SAFETY EVALUATION
PILGRIM NUCLEAR POWER STATION

Description of Proposed change, test, or experiment: Evaluate results of a design
verification for safety related cooling systems using the FSAR site maximum salt
service water temperature of 75°F. Revise the FSAR to reflect the analysis results.
Revise Technical Specification Bases 3/4.7.A regarding local suppression pool
temperature limits (See Attachment C for markup).

Comments: This safety evaluation revises the suppression pool temperature
bases for TS 3.7.A. See "Analysis of Effect on Safety Functions" in Att. A.

Figure 14.5-17 Design Basis Loss of Coolant Accident - Containment Temperature Response
75°F SSW Case

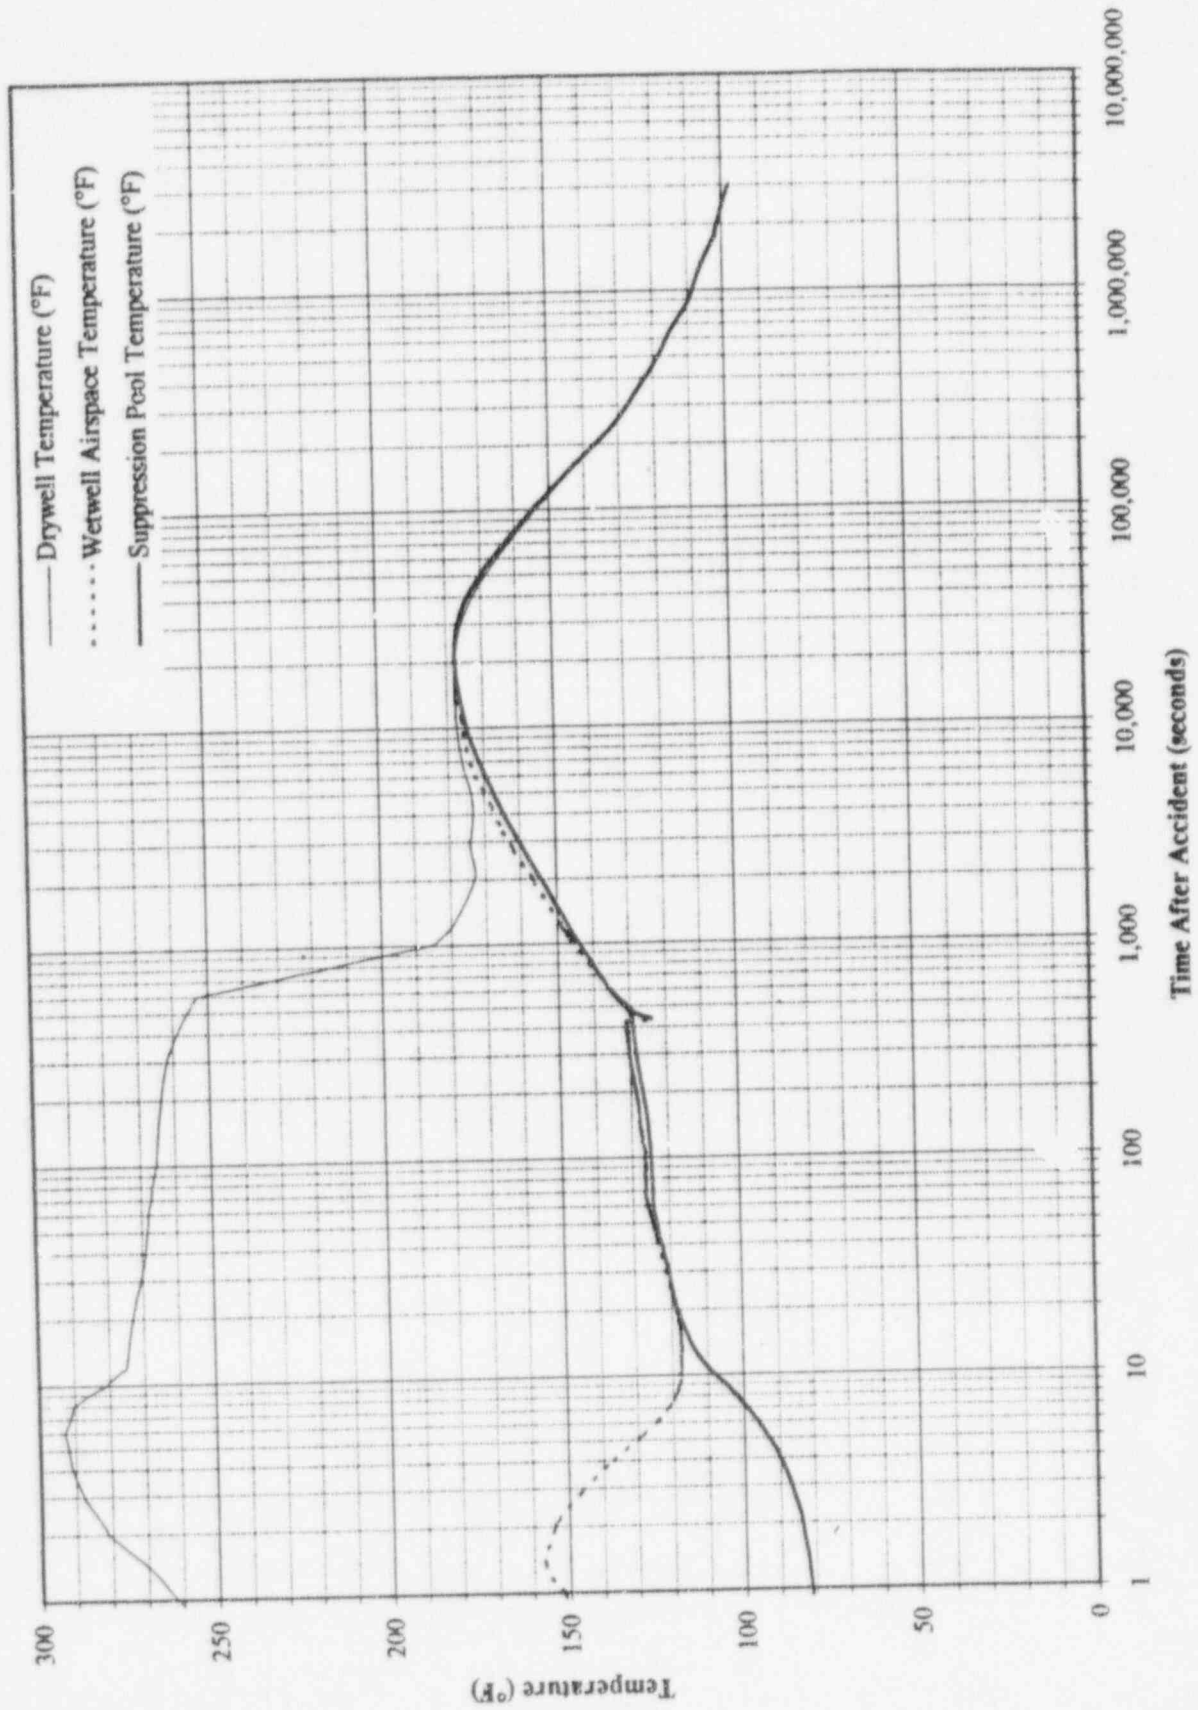
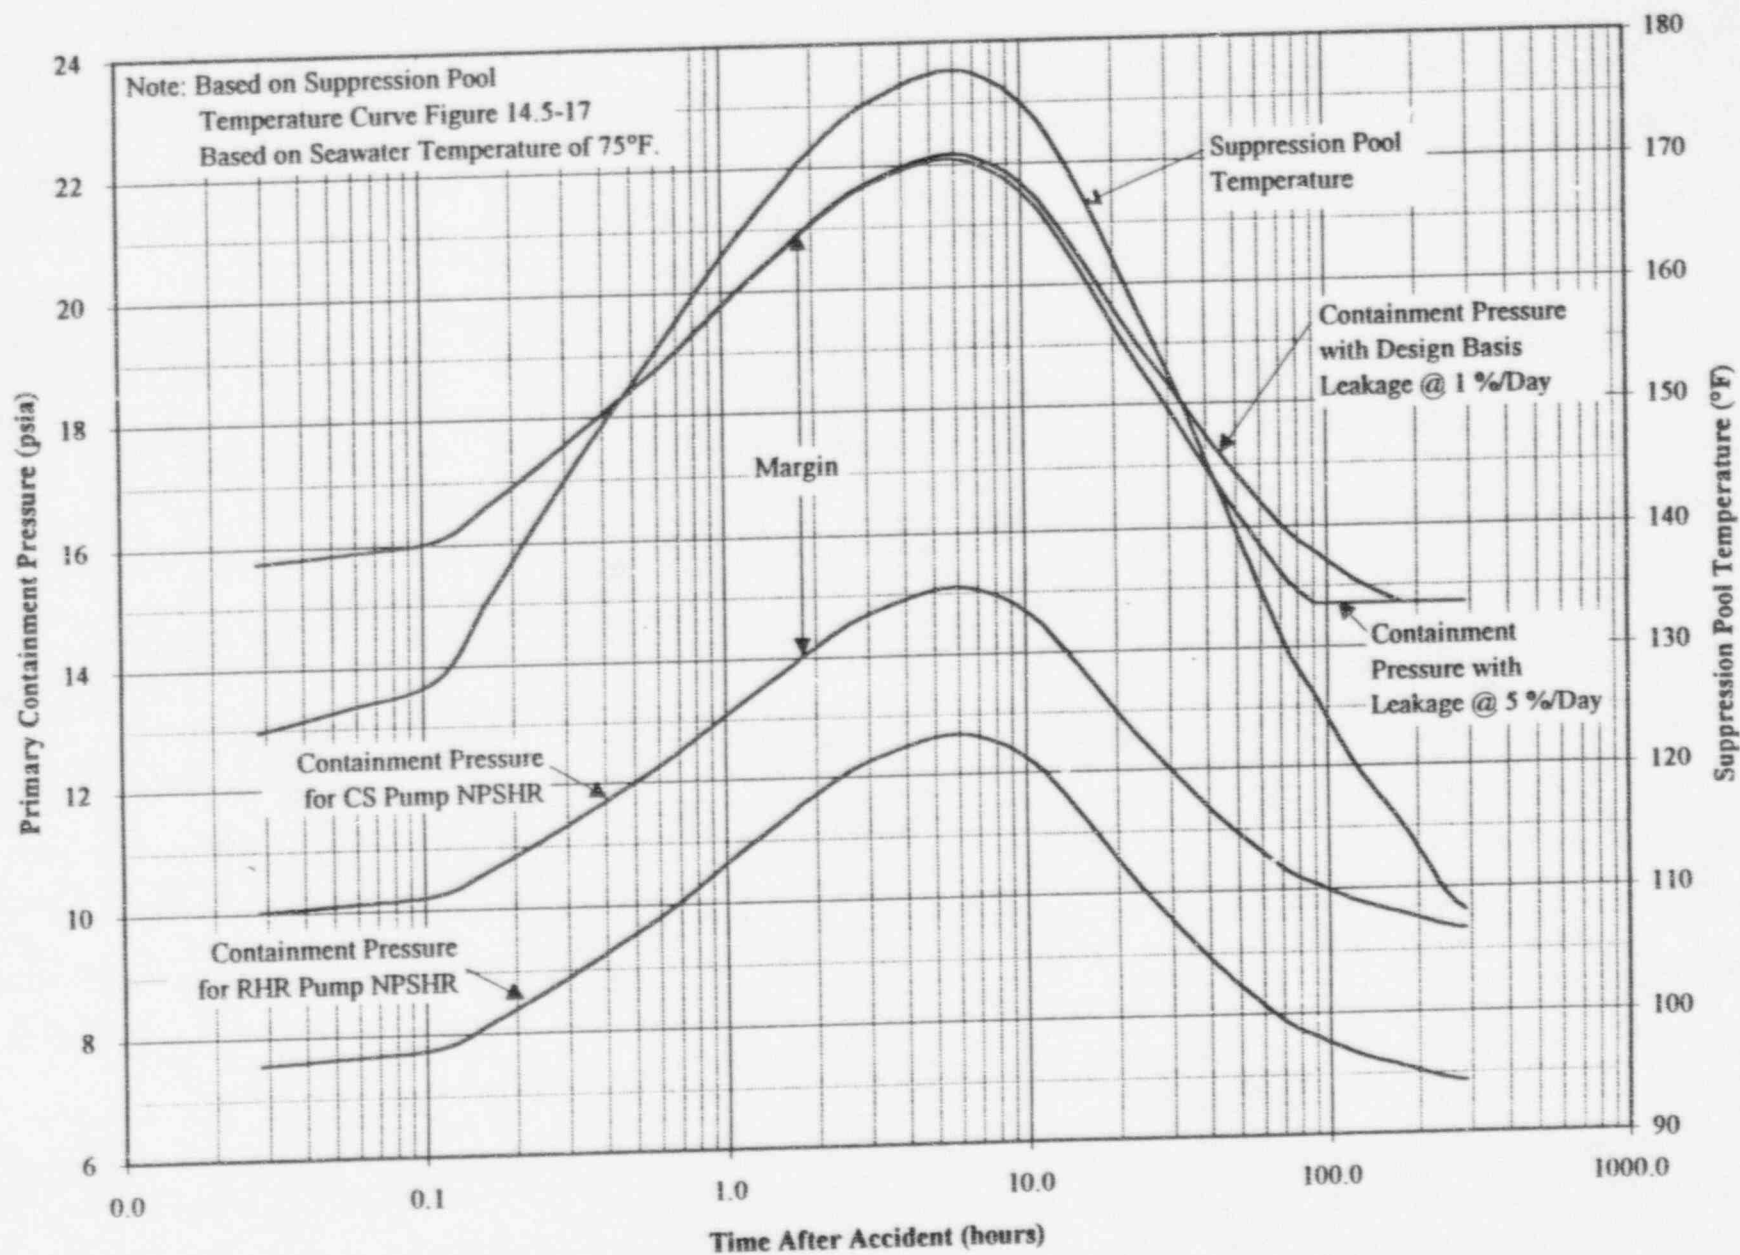
For the 75°F SSW Case, the calculated pressure and temperature responses of the containment are shown on Figures 14.5-16, and 14.5-17. The short-term response of the drywell, wetwell, and suppression pool is the same as for the Case B from the 65°F SSW Case. The containment response prior to 600 seconds is unaffected by containment cooling and remains the same for both cases. The 65°F SSW Case provides additional description of the short-term response.

The peak suppression pool temperature of 178°F, which is much less than the containment temperature design limit of 281°F occurs between 5 to 6 hours after the start of the accident. The suppression pool temperature response is shown on Figure 14.5-17 and a summary of equipment capability assumed in the analysis is shown in Table 14.5-2.

18. **Add new Table 14.5-2 [see attached]**
19. **Add new Figures 14.5-16, 14.5-17, 14.5-18, 14.5-19 [see attached]**
20. **Replace Section 14.5.3.1.3 "Core Standby Cooling System Pump Net Positive Suction Head" with the following [see markup]**

Figure 14.5-19 NPSH Margin for RHR and Core Spray Pumps After a DBA-LOCA

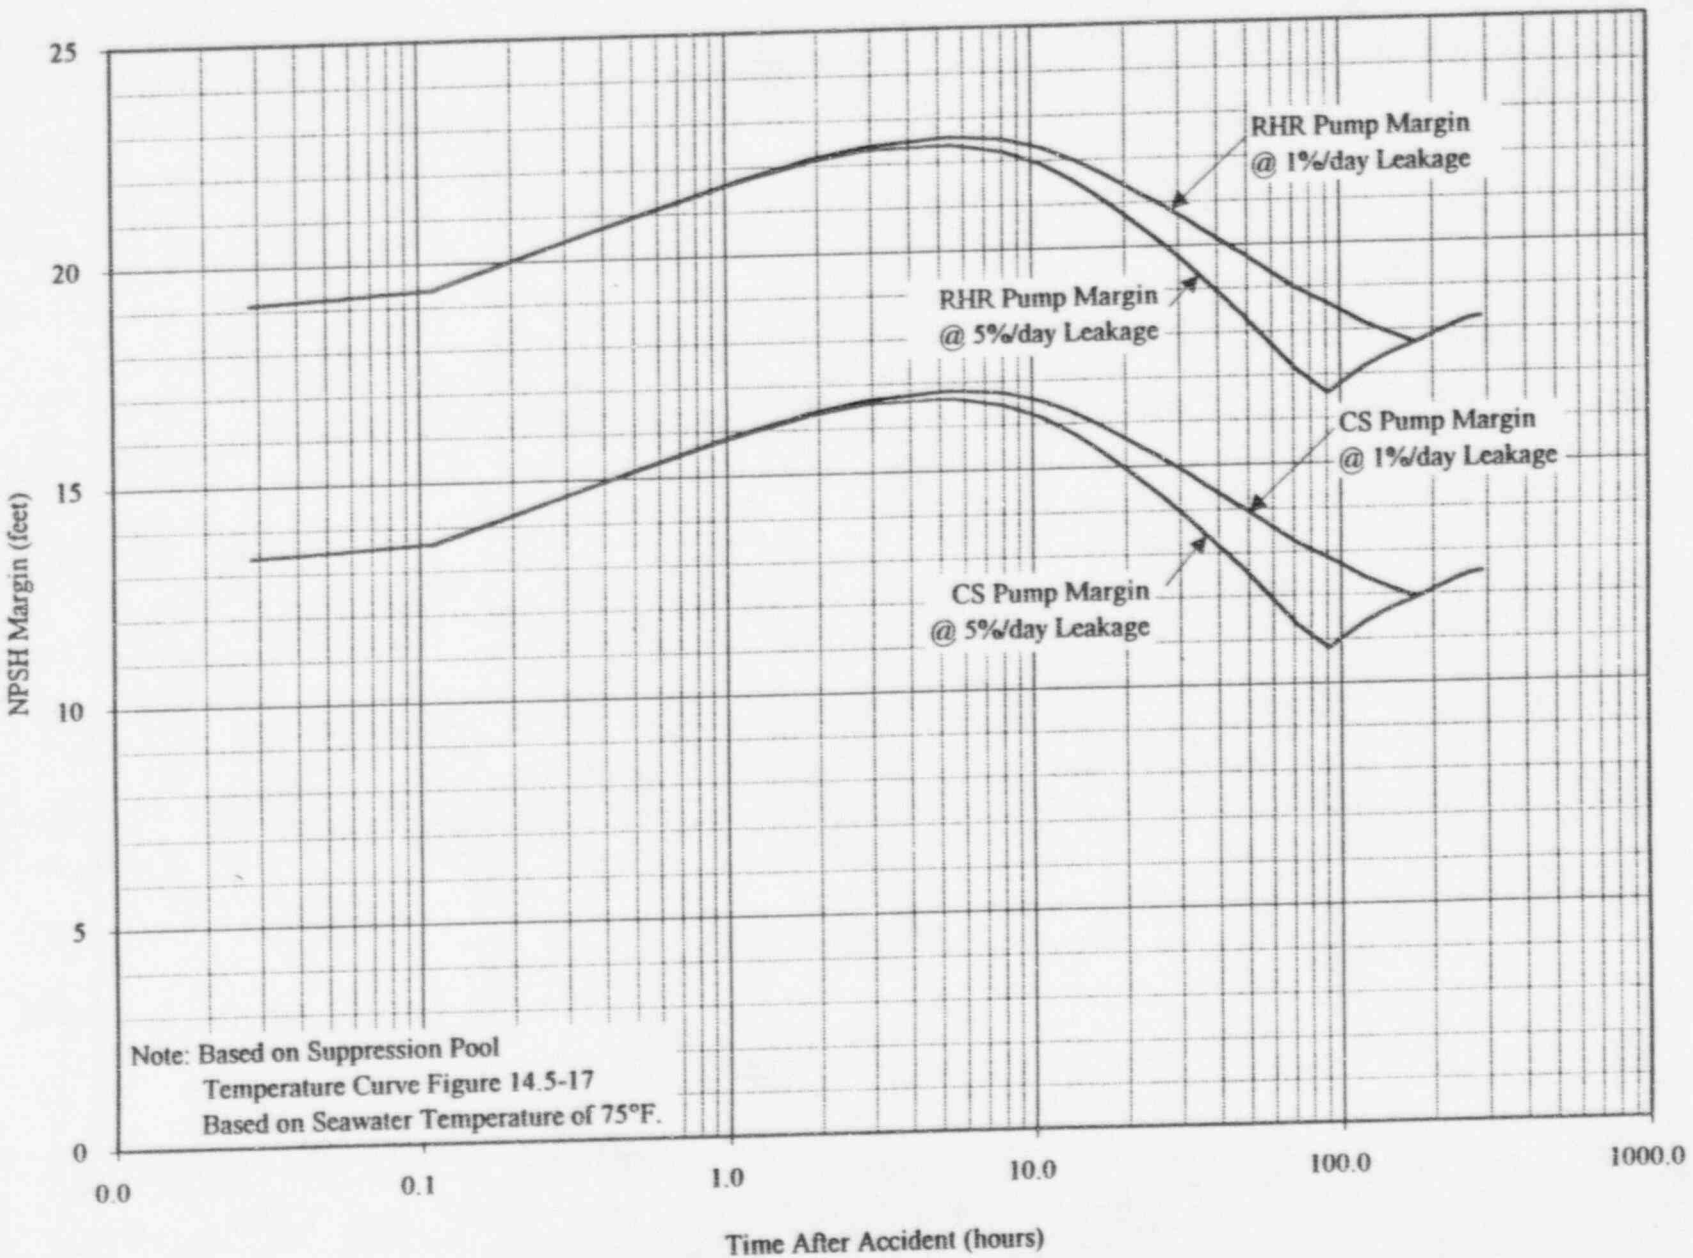
NPSH margin for the 75°F SSW Case, with leakage effects included, is presented on Figure 14.5-18 and 19. Here, the suppression pool temperature and containment pressure are shown as a function of time. Also shown is the primary containment pressure required to provide the required NPSH to the RHR and Core Spray pumps at their maximum required flow rates. As can be seen, substantial margin exists throughout the duration of the event. Therefore, it can be concluded that adequate NPSH will be available at all times following a design basis LOCA for the 75°F SSW Case.
